MOOLARBEN COAL COMPLEX OC3 EXTENSION PROJECT

SUBMISSIONS REPORT

Figure 4-12

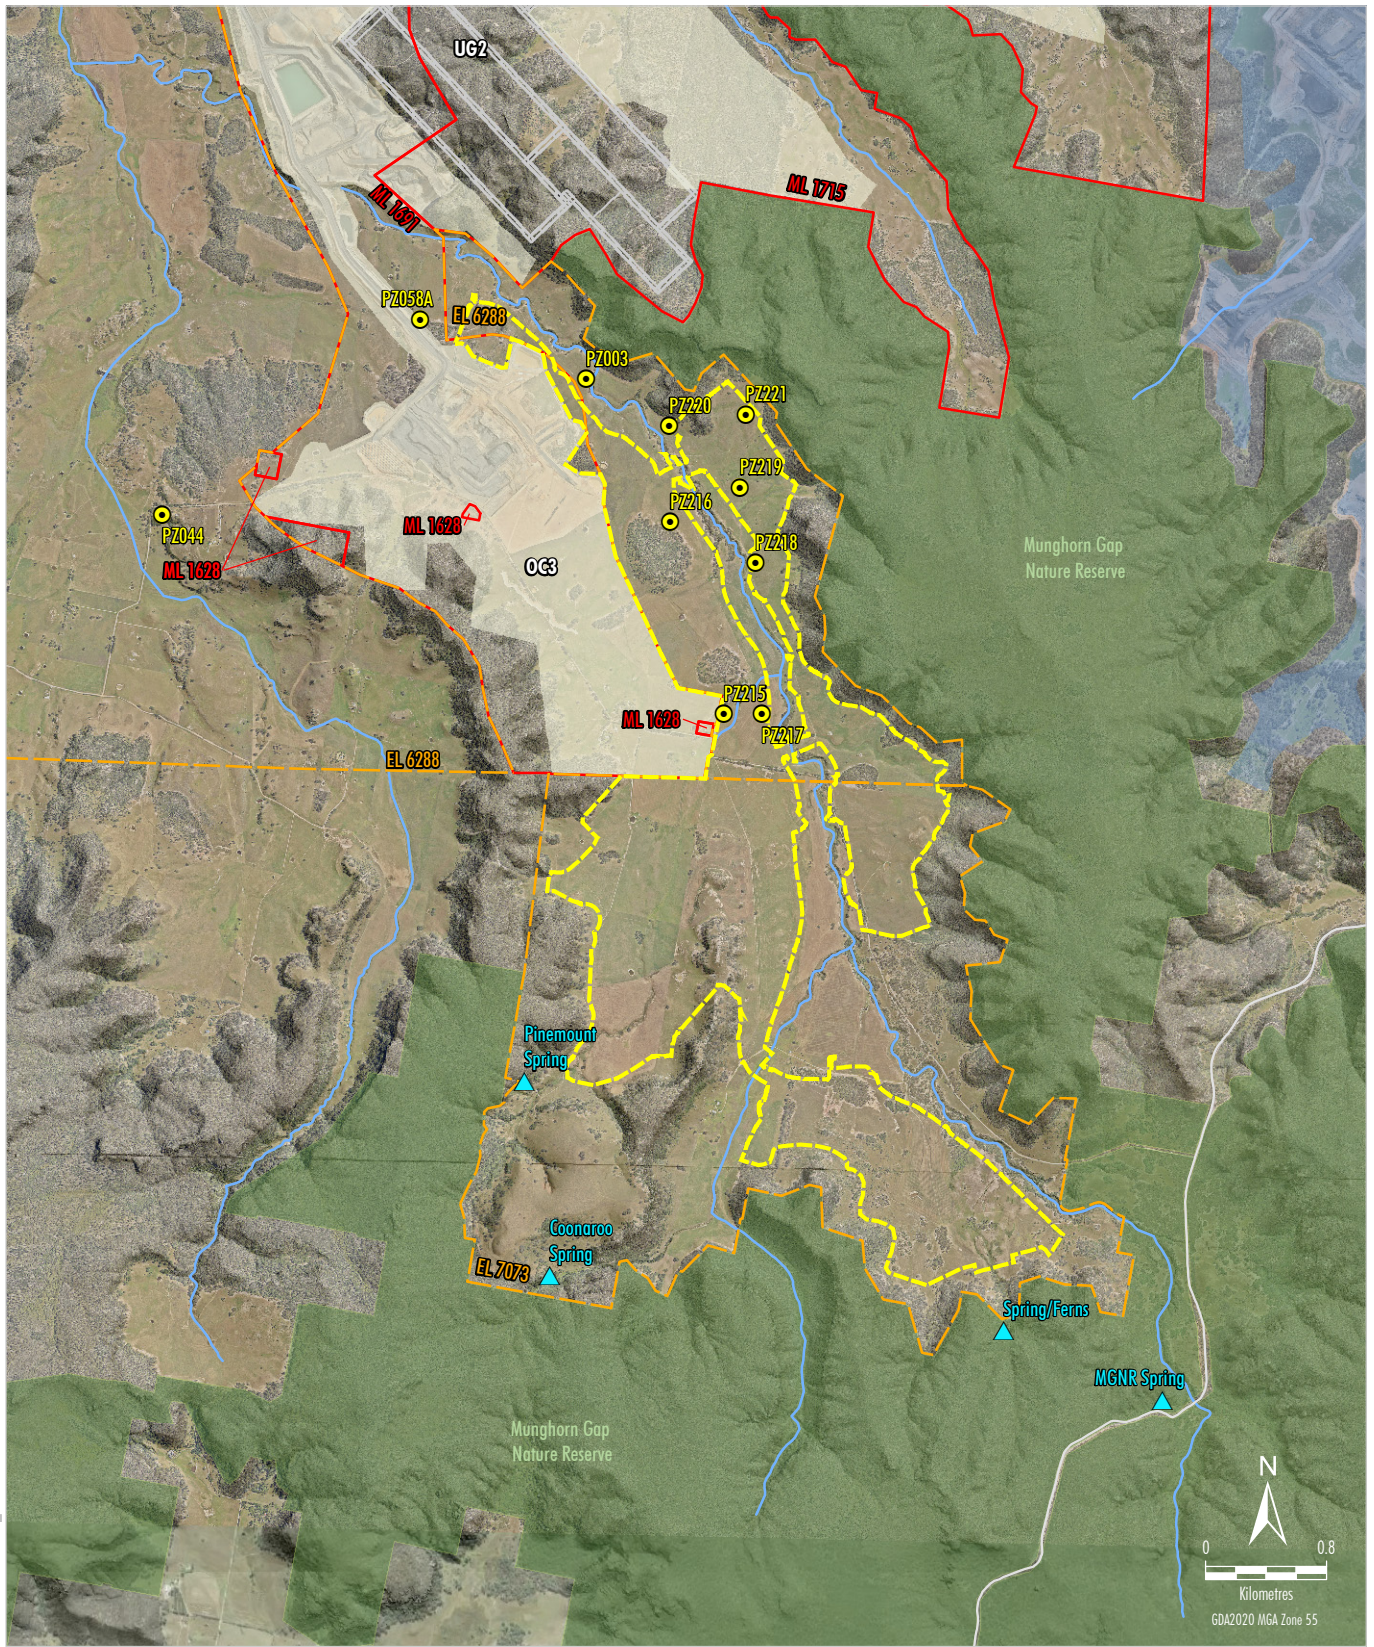
NPWS requested an additional round of stygofauna sampling be undertaken within the bores sampled in the Project Area for the EIS Aquatic Ecology Assessment, consistent with relevant guidelines. Additional monitoring of the bores sampled within and surrounding the indicative surface disturbance extent for the Project was undertaken by Bio-Analysis (2023) on 26–28 September 2023 (Figure 4-12).

NPWS also recommended targeted stygofauna sampling within groundwater spring features identified to the south of the Project area, including the Pinemount Spring, Spring/Ferns, Coonaroo Springs and Munghorn Gap Nature Reserve Spring (Figure 4-12). Two rounds of sampling of the spring features was undertaken by Bio-Analysis (2023) in September and October 2023.

Stygofauna testing locations are shown on Figure 4-12. Further detail on the outcomes of these surveys is provided below.

Figure 4-16: Survey Units and Landform Areas within the Subject Area (Source: Niche, 2024b)

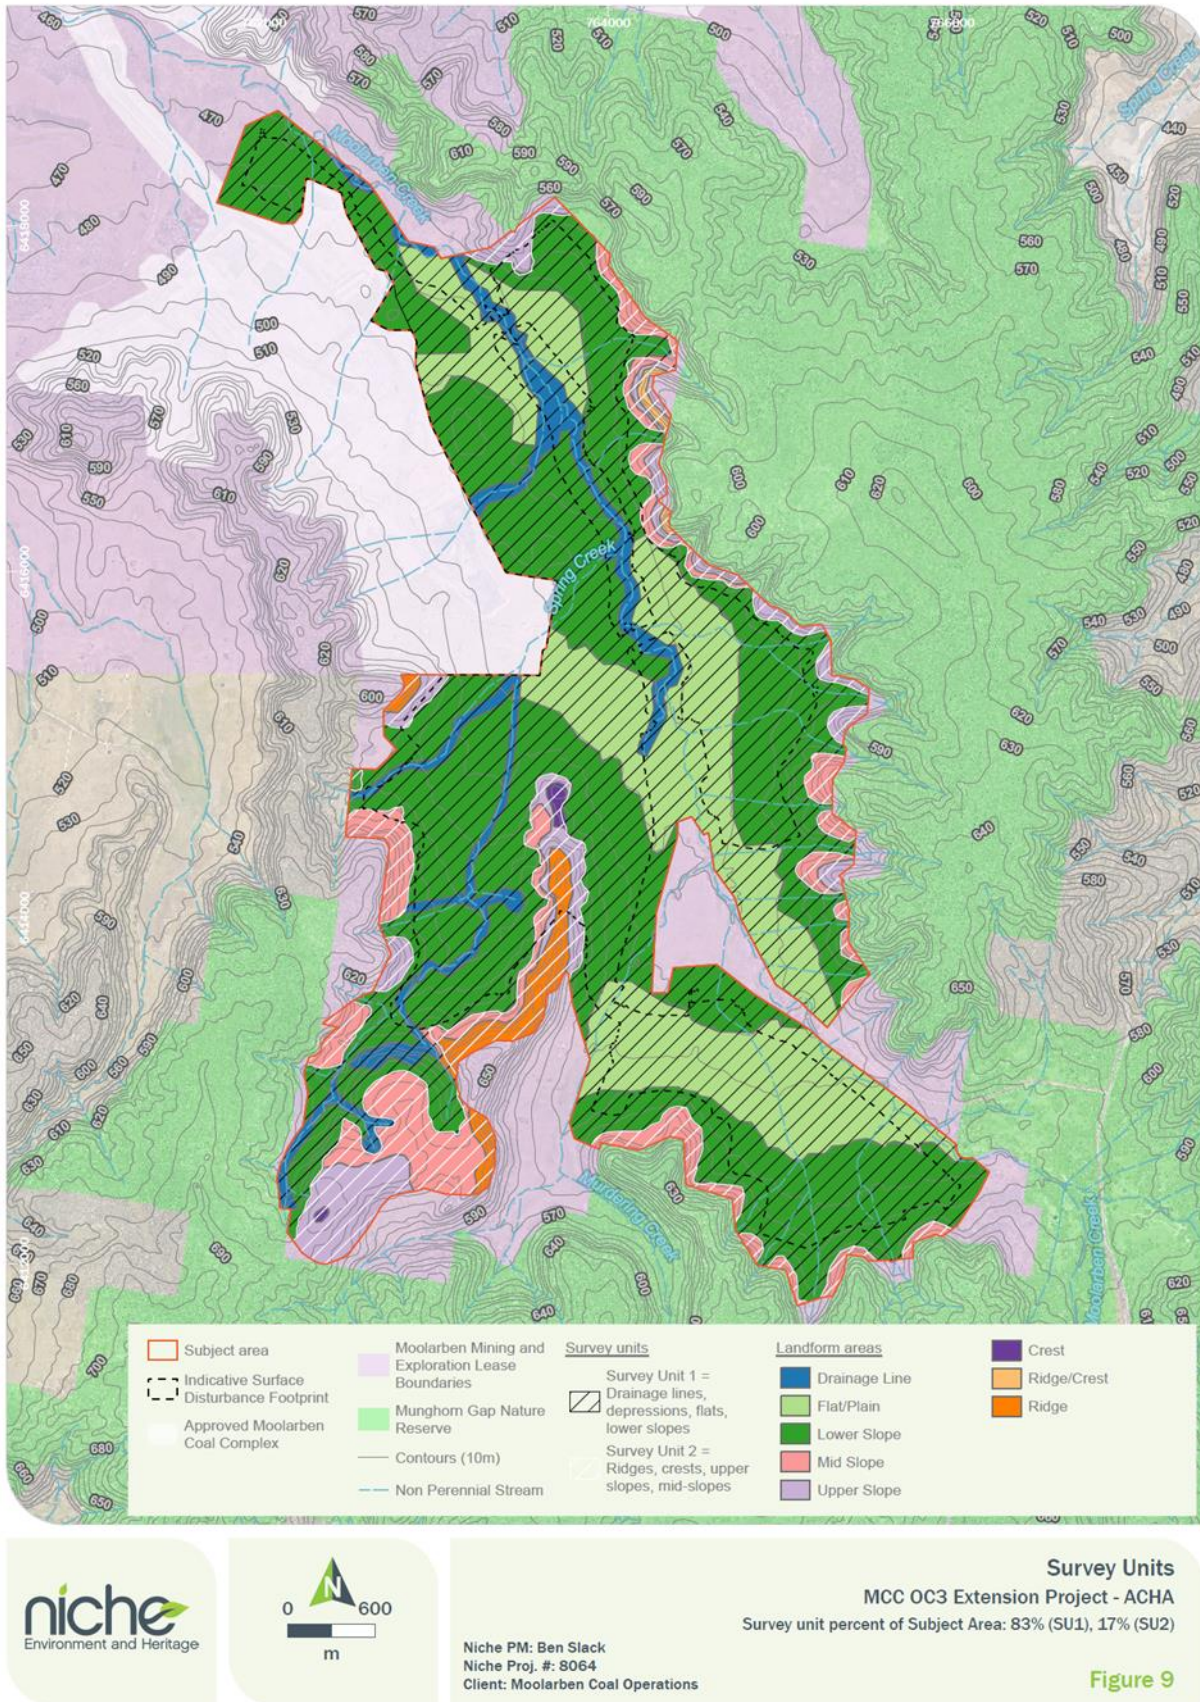
- *Figure 8 of the ACHAR outlines that survey conducted within Survey Unit 1 focused on disturbed access tracks, rather than investigating areas along Moolarben Creek and areas of remnant vegetation. Further detail on the extent of surveys conducted in Survey Unit 1 is recommended.*

Since lodgement of the ACHA as presented in the EIS, Niche (2024b) have revised the ACHA and Archaeological Report to provide the breakdown of landform areas within the survey units. Figure 4-16 shows the landforms areas within the Subject Area and associated survey units. Table 4-5 provides the total area surveyed for each landform during the 2022 and 2023 survey programs.

Since lodgement of the ACHA as presented in the EIS, Niche (2024b) has revised the ACHA and AR to provide the breakdown of landform areas within the survey units developed for the survey program undertaken in 2022 (Table 4-5 and Figure 4-16). Further detail is provided in the response to Recommendation 3.1.

Figure 4-21: Moolarben Creek and Goulburn River Catchments and Project-only and Cumulative Catchment Excision (Source: WRM, 2024).

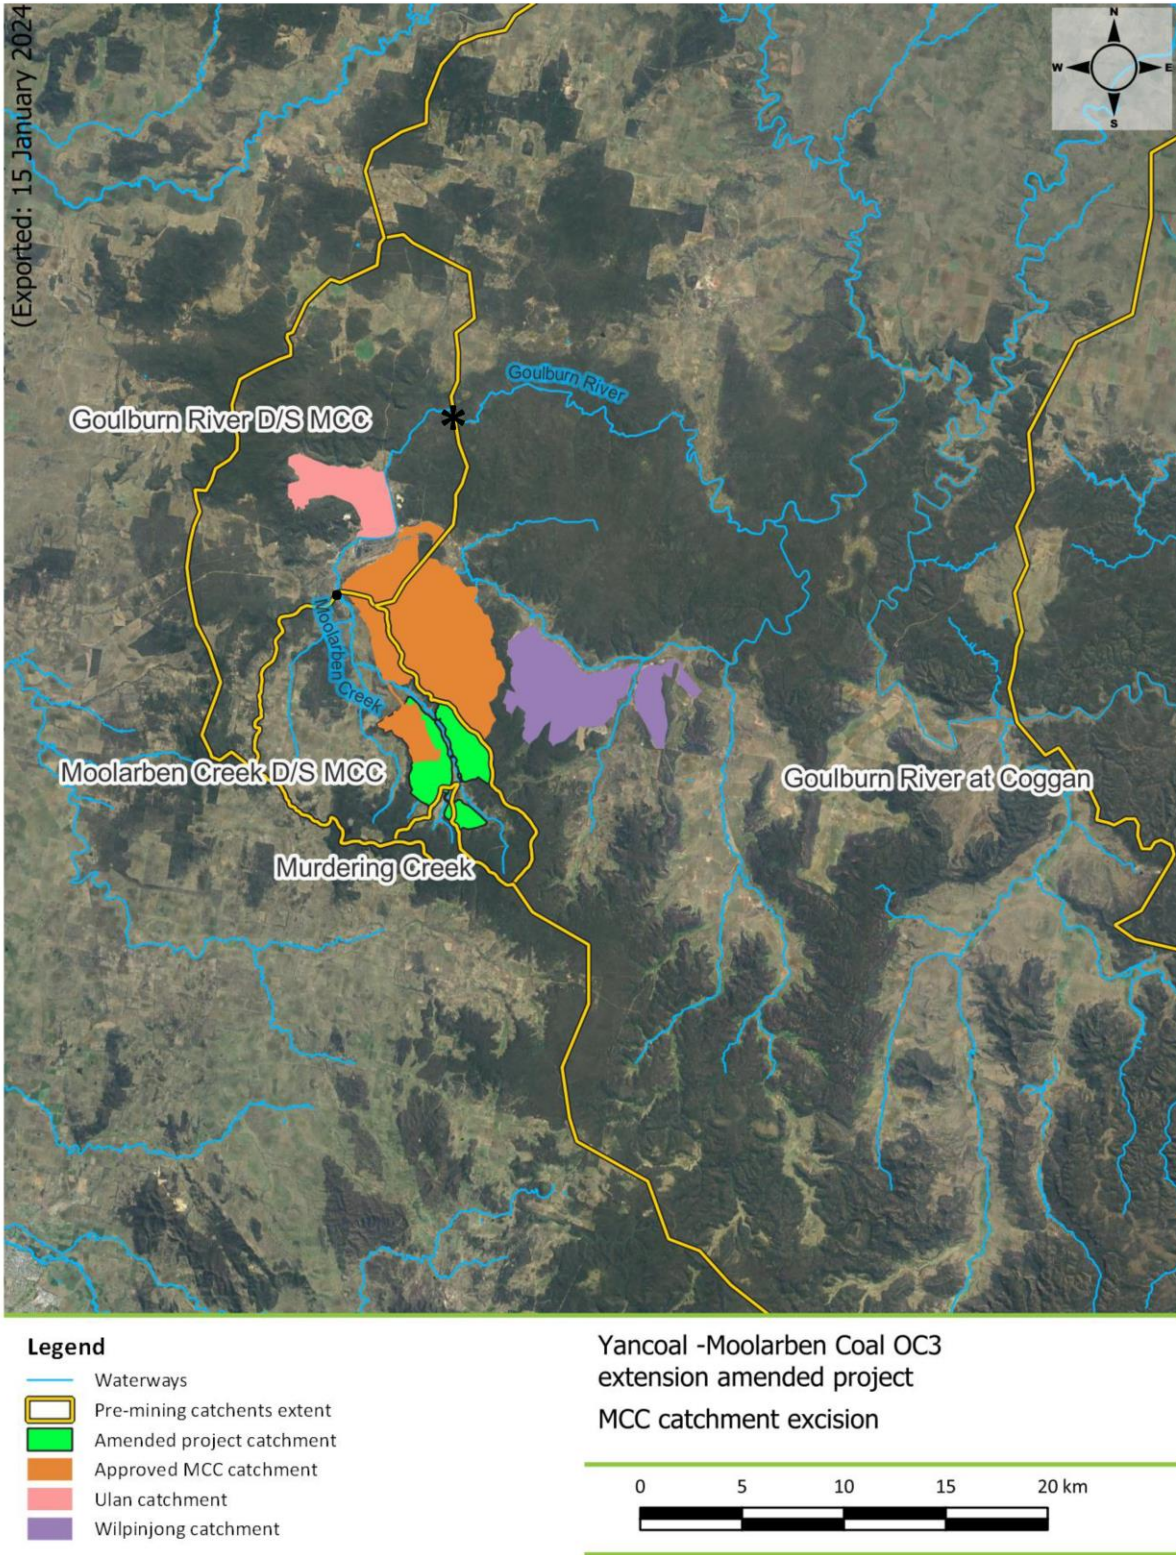
3. *Loss of streamflow due to reduced catchment size (up to 16% of the Moolarben Creek catchment) was described by the proponent as indiscernible and likely to cause only negligible impacts to watercourses (WRM 2022, p. 97). Currently, insufficient data are presented to justify this conclusion, particularly as the spatial arrangement of the excised area may exacerbate impacts to run-off and infiltration. Excision of up to 16% of the catchment area, including the removal of at least 16 km of ephemeral drainage channels (Bio-Analysis 2022, Figure 4, p. 7) and associated infiltration patterns are likely to reduce the extent and quality of aquatic habitats over the life of the project. The IESC notes that Moolarben Creek is already moderately stressed but recommends that project-related impacts from altered flow regimes should be evaluated and include an assessment of the contribution to cumulative impacts from this project.*

- Catchment excision of the amended Project indicative surface disturbance extent is shown in Figure 4-21 and represents:
 - a maximum of approximately 11% of the Moolarben Creek catchment (downstream of the Project) at the confluence with the Goulburn River;

Figure 4-24: Plot of Observed Groundwater Levels against the Modelled Groundwater Levels for Monitoring Bores within the Alluvial Sediments and Paleochannel Unit at the Local Scale of the Project (Source: AGE, 2024)

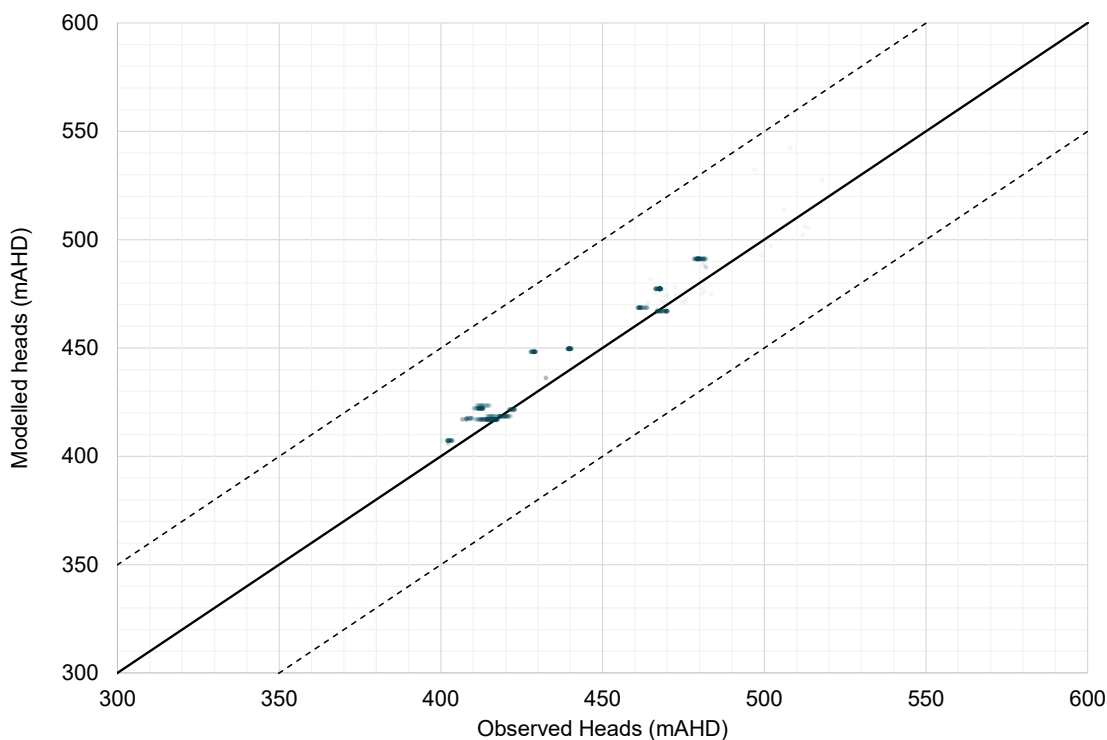
- b. *There is a discrepancy of three orders of magnitude between field-tested and modelled hydraulic conductivity of the alluvium. Tested hydraulic conductivities of the alluvium are quoted as being between 0.05 and 3 m/d with a median of 0.4 m/d, (AGE 2022, Table 5.4, p. 37 and Figure 5.2, p. 38), while the range in the calibrated model is from approximately 14 to 50 m/d, with 44.8 m/d highlighted (AGE 2022, Att. C, Figure C 5.20, p. 38 and Table C 5.1, p. 36). The reasons for, and influence of, this discrepancy have not been explored. The alluvium within the model may be acting as a surrogate parameter, and appears to have been poorly constrained by the calibration process. The proponent presents summary results for two sets of hydraulic conductivity testing, but the location of these tests and their proximity to the mine extension area are not presented.*

Figure 4-24 provides a local scale plot (e.g. within the Project area) of the observed groundwater levels against the modelled groundwater levels at groundwater monitoring bores within the alluvial sediments and paleochannel at the local scale only. The groundwater model has an SRMS of 6.8% at groundwater monitoring bores within the local scale for the Project, which is also within the target SRMS of less than 10%.

Figure 4-25: Long-term Hydrograph at Quaternary Alluvium Observation Point 1 over the Recovery Phase (Source: AGE, 2022)

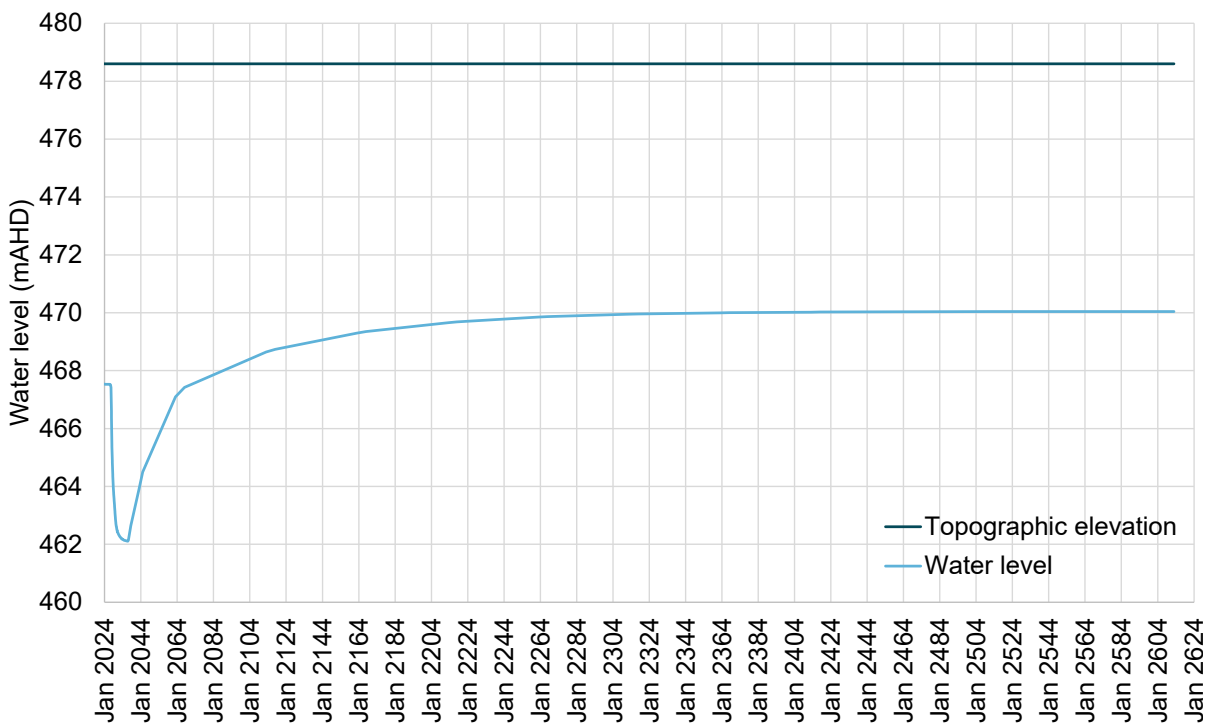
11. *The recovery phase comprises 14 stress periods which represent 576 years (AGE 2022, Att. C, p. 11). The rationale behind this timeframe selection, which is an order of magnitude longer than the calibration period and likely to increase uncertainty, should be presented. Additionally, the proponent should provide model outcomes identifying when equilibrium has been reached (refer to AGE 2022, Figure 5.6, p. 99).*

A 576-year timeframe for the modelled recovery phase was adopted by AGE (2022) for the groundwater model as it allowed sufficient time for a pseudo-equilibrium to be reached as shown in Figure 4-25, which provides a long-term hydrograph for a Quaternary alluvium observation Point 1 in the Project area (shown in Figure 4-13). Figure 4-25 also shows that after approximately 30 years, the groundwater level is predicted to recover to pre-mining levels within the range of natural variation.
